PROJECT TITLE: CROWNELL ARCHITECTS SPRINGDALE PHILANDER SMITH VOLUME 2

FLOOR/AREA: AUDITORIUM & BALCONY

DRAWING NO.: D781526-00-00-L01-F

SHEET: Seating (1)

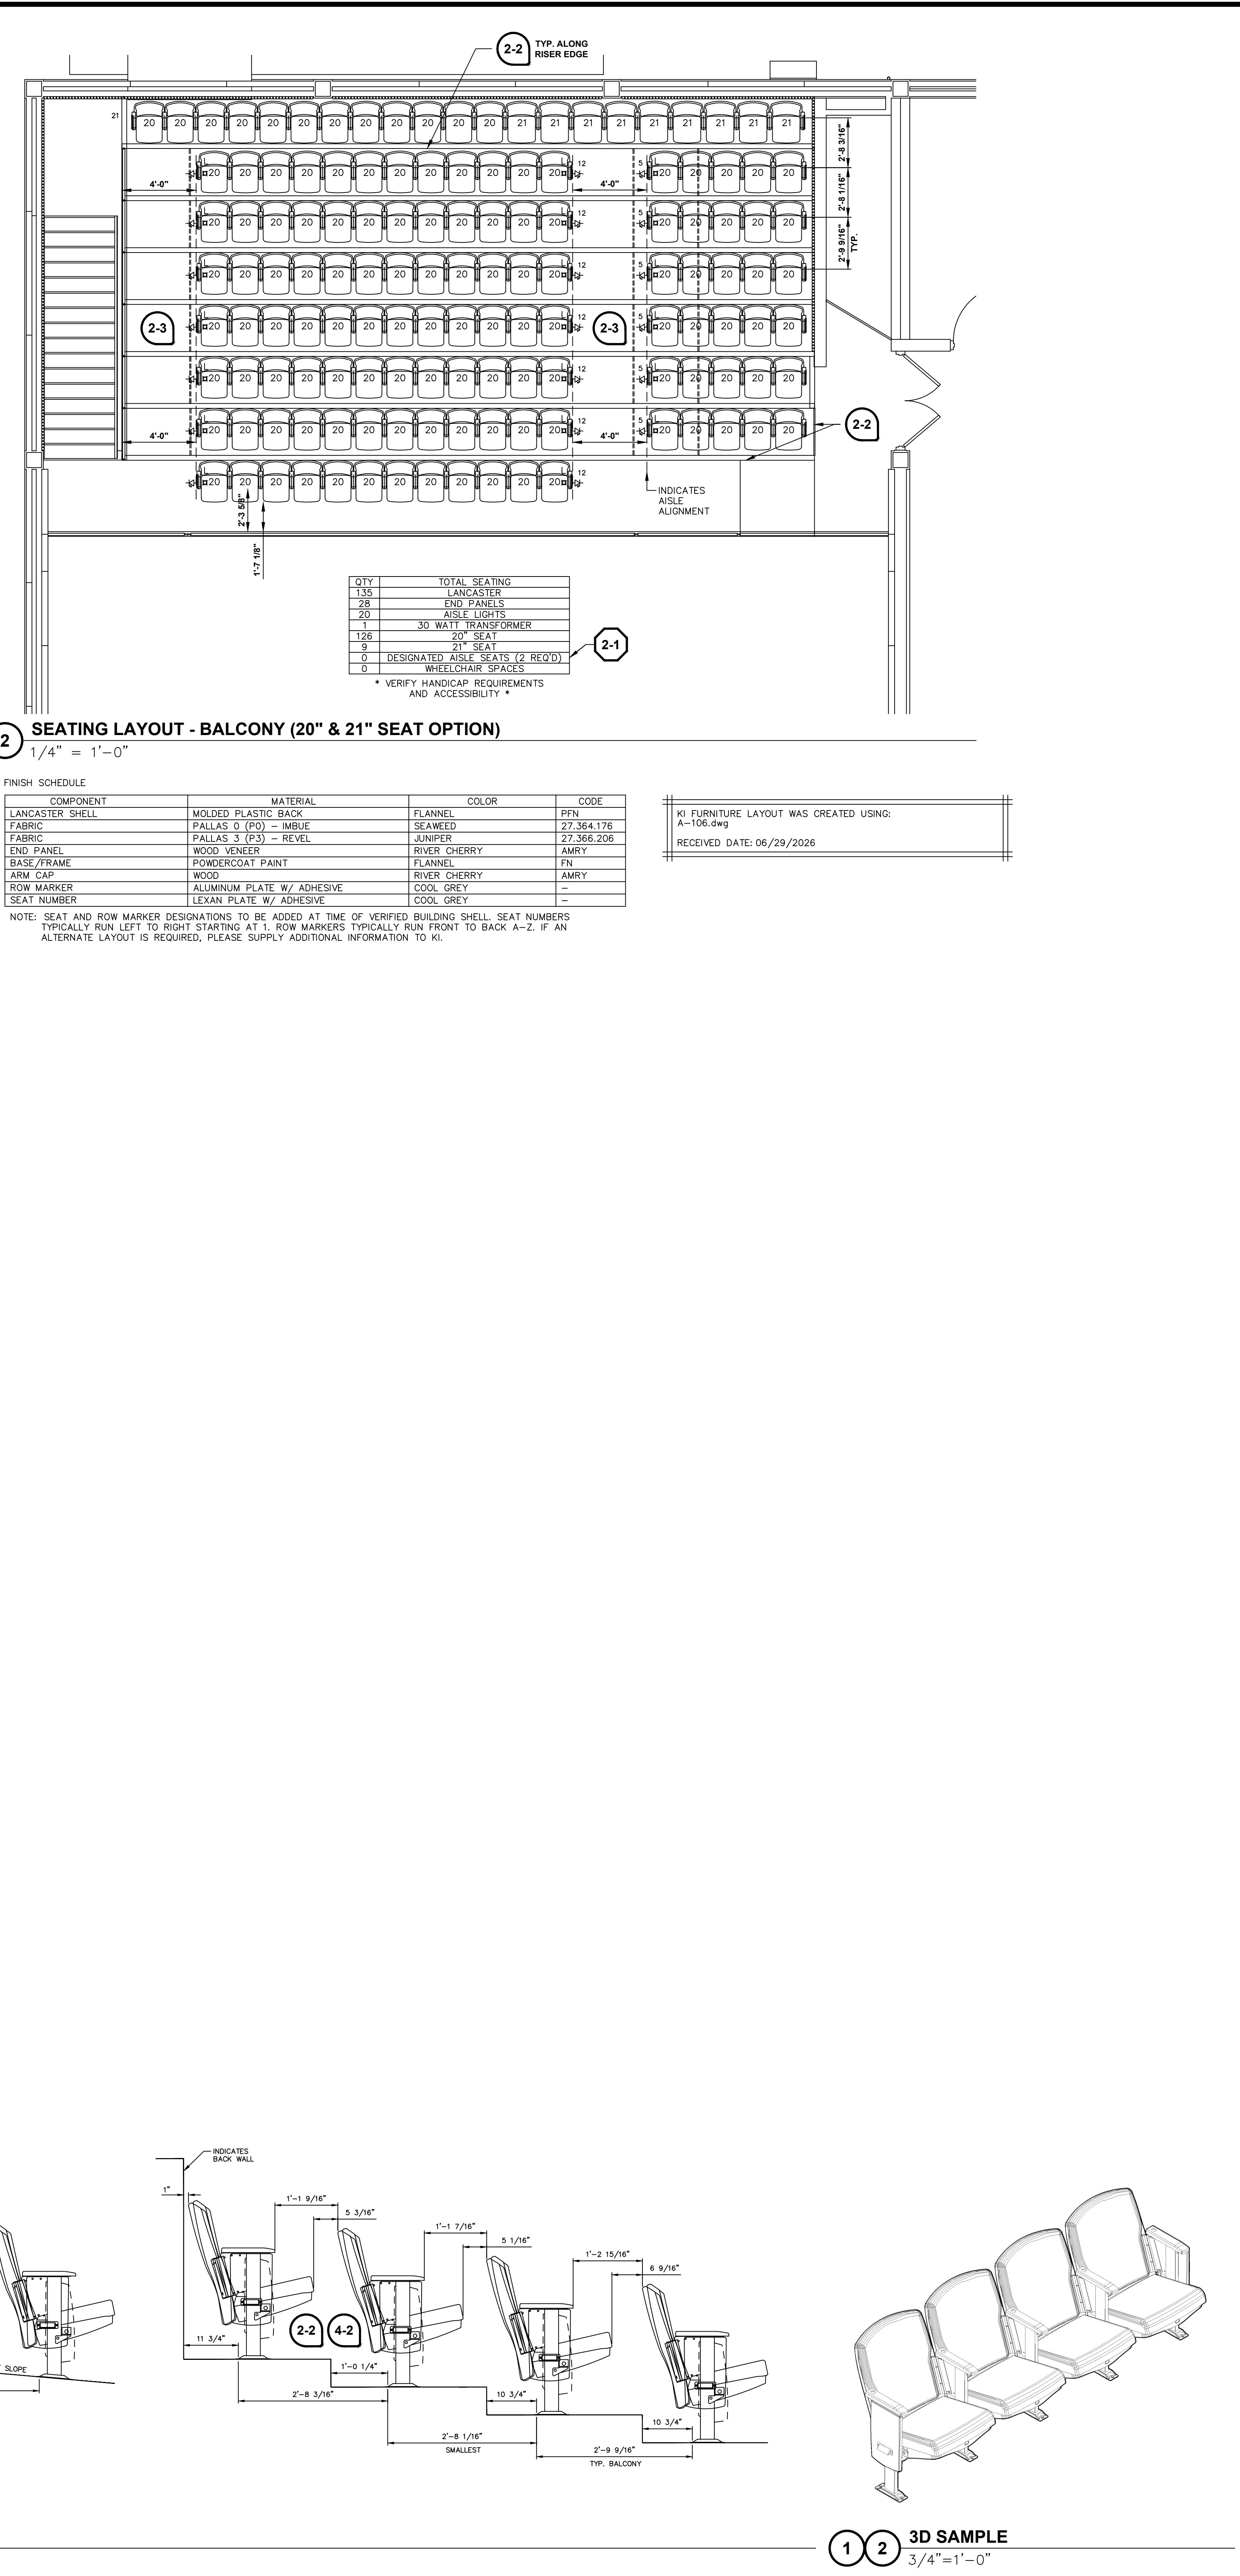
THE QUANTITY OF WHEELCHAIR SPACES IN THIS ROOM DOES NOT COMPLY WITH **IBC 118.2.3.1** WHICH INDICATES THAT SEATING CAPACITIES OF 501 TO 5,000, REQUIRE 6 WHEELCHAIR SPACES PLUS 1 MORE FOR EVERY 150 SEATS OR FRACTION THEREOF BETWEEN 501 & 5,000 (& CORRESPONDING COMPANION SEATS).

PER **IBC 118.2.3.2** EACH WHEELCHAIR SPACE IS REQUIRED TO HAVE A COMPANION SEAT WHICH ALLOWS FOR SHOULDER TO SHOULDER ALIGNMENT AS INDICATED BY **IBC A117.1.5.9.2.2**.

PER **IBC 118.2.3.2** AT LEAST ONE BUT NOT LESS THAN ONE OF THE TOTAL NUMBER OF SEATS SHALL BE IDENTIFIED WITH THE INTERNATIONAL SYMBOL OF ACCESSIBILITY AND BE LOCATED CLOSEST TO AN ACCESSIBLE ROUTE.

PLEASE VERIFY ELEVATION CHANGE IN THIS AREA. A GUARD MAY BE REQUIRED TO PREVENT A TRIP HAZARD.

PLEASE VERIFY ANY HANDRAILS THAT MAY BE REQUIRED ALONG THIS AISLE. PLEASE COMMUNICATE THE SIZE & LOCATION OF ANY HANDRAILS NOT SHOWN ON THIS PLAN.

*** HANDRAILS AT A CENTER AISLE 21" (584mm) MINIMUM FROM EDGE OF SEAT TO EDGE OF HANDRAIL (IBC 108.3.3)**

*** HANDRAILS AT SIDE AISLES: SIDE HANDRAILS ARE PERMITTED TO PROTRUDE 4 1/2" (114mm) INTO THE AISLE, ANYTHING GREATER THAN THIS WILL INFRINGE ON MINIMUM AISLE REQUIREMENTS (IBC 1014.8)**
